U.S. CONSUMER PRODUCT SAFETY COMMISSION
4330 EAST WEST HIGHWAY
BETHESDA, MD 20814

May 25, 2010

Point-by-Point response

List of all planned modifications to Public Playground Safety Handbook

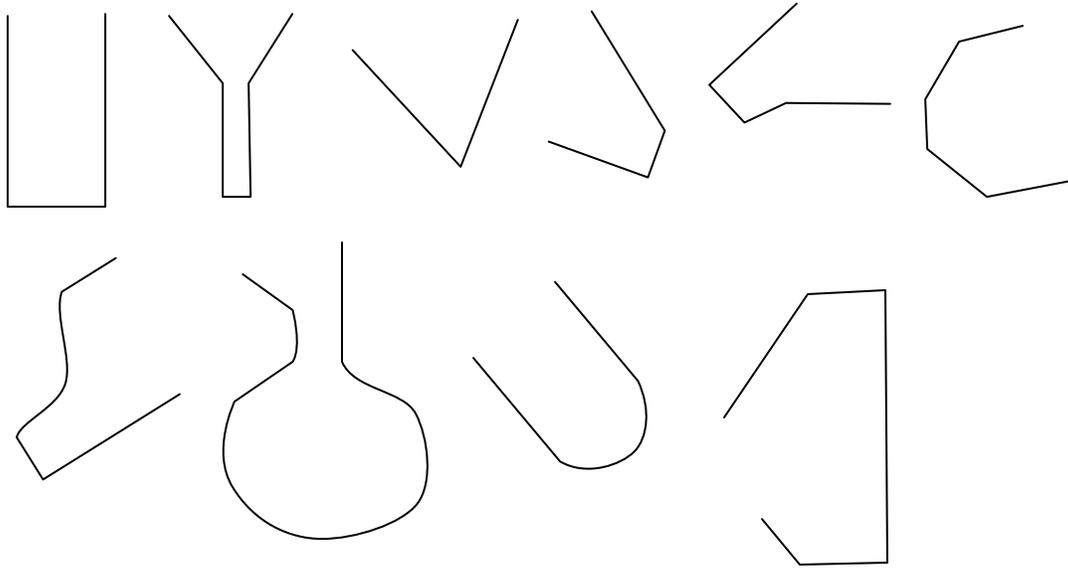
65. B.2.4 Angles: Delete section in its entirety, as it has been replaced by new section on Partially Bound Openings.
66. B.2.6.5 Flexible openings, Step 5: Modified to read “Determine *if* the probe can be pushed or pulled *completely* through the opening by a force no greater than 30 pounds on toddler playgrounds or 50 pounds on preschool-age and school-age playgrounds.”
67. B.2.6.5 Flexible openings, Step 5: Add representative Pass and Continue pictures provided.
68. B.2.6.5 Flexible openings, Step 7: Modified to read “Determine if the large head probe can be pushed or pulled *completely* through the opening by a force no greater than 30 pounds on toddler playgrounds or 50 pounds on preschool-age and school-age playgrounds.”
69. B.2.6.5 Flexible openings, Step 7: Add representative Pass and Fail pictures provided.
70. Appendix B: Add new section B.2.6.6 Partially Bound Openings.

A partially bound opening is any opening which has at least one side or portion open, such as a U- or V-shaped opening. These openings can still pose an entrapment hazard by allowing the neck to enter but not allowing the head to slip out. Several examples of this situation are shown in the figure below.

Note: Test procedure write-up is still in development and usability testing. Above graphics to be improved by graphic artist.
